SUBJECT: CORRECTION PAGES TO AMENDMENTS 87 AND 65 FOR VOGTLE NUCLEAR PLANT,
UNITS 1 AND 2, TECHNICAL SPECIFICATIONS

The Commission issued Amendments 87 and 65 to Facility Operating Licenses NPF-68 and NPF-81 for the Vogtle Electric Generating Plant, Units 1 and 2, Technical Specifications on June 9, 1995. Enclosed are revised pages to replace pages 3/4 4-31 and 3/4 4-31a. These pages are the same as those previously issued by the NRC except for the labeling of two pressure versus temperature curves that was inadvertently omitted from your application and, subsequently, Amendments 87 and 65.

Figure 3.4-2a

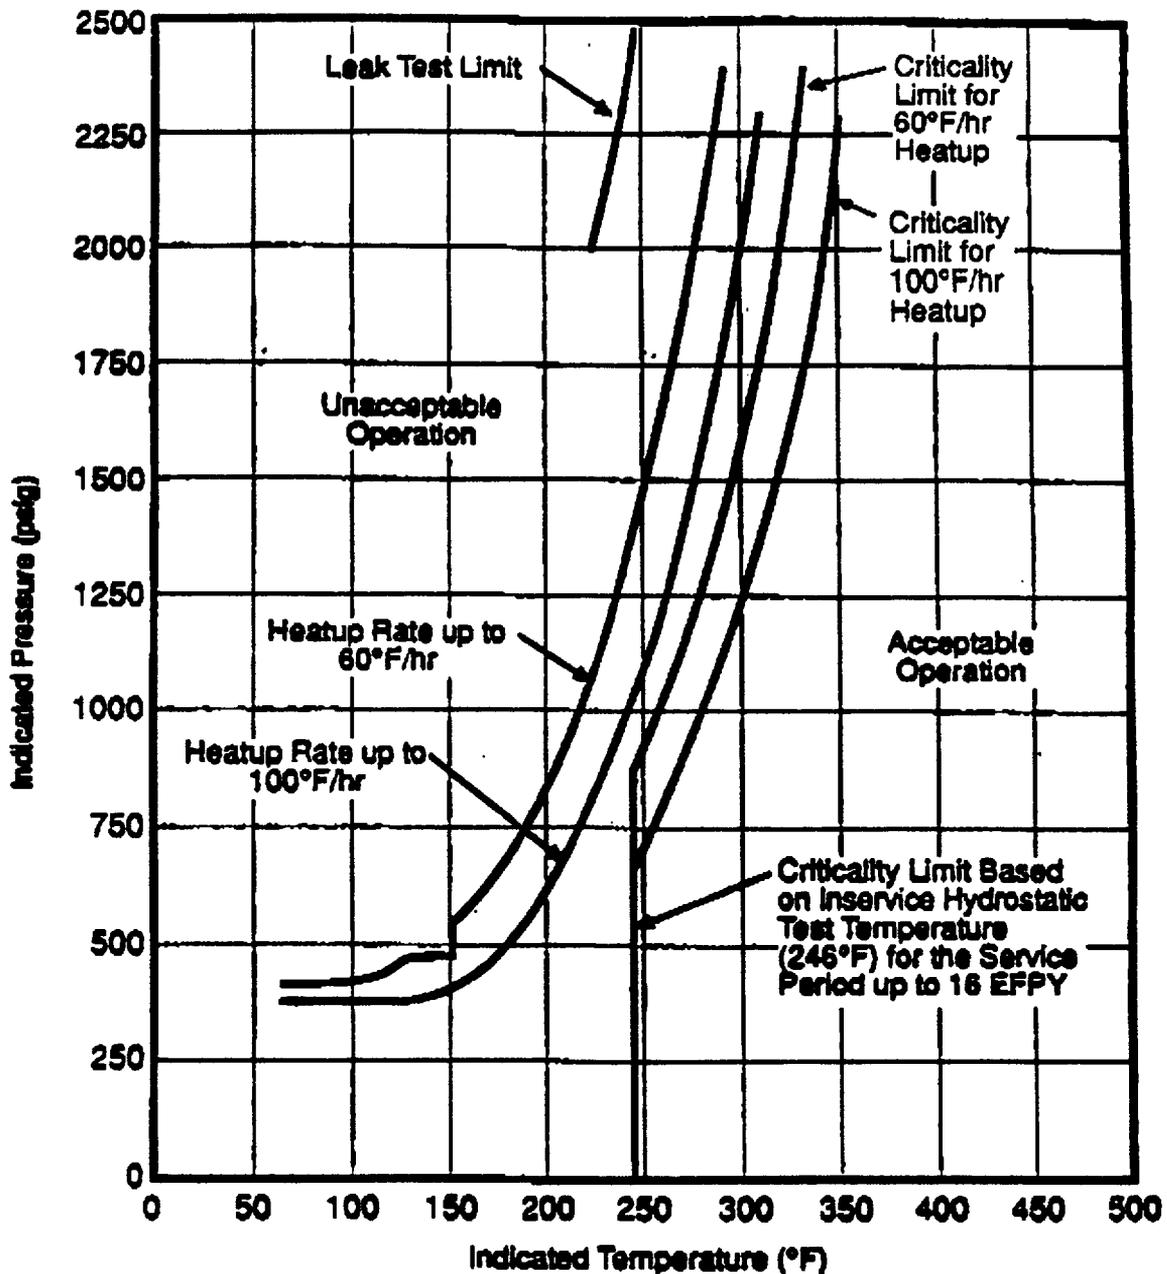
The Commission issued Amendments 87 and 65 to Facility Operating Licenses NPF-68 and NPF-81 for the Vogtle Electric Generating Plant, Units 1 and 2, Technical Specifications on June 9, 1995. Enclosed are revised pages to replace pages 3/4 4-31 and 3/4 4-31a. These pages are the same as those previously issued by the NRC except for the labeling of two pressure versus temperature curves that was inadvertently omitted from your application and, subsequently, Amendments 87 and 65.
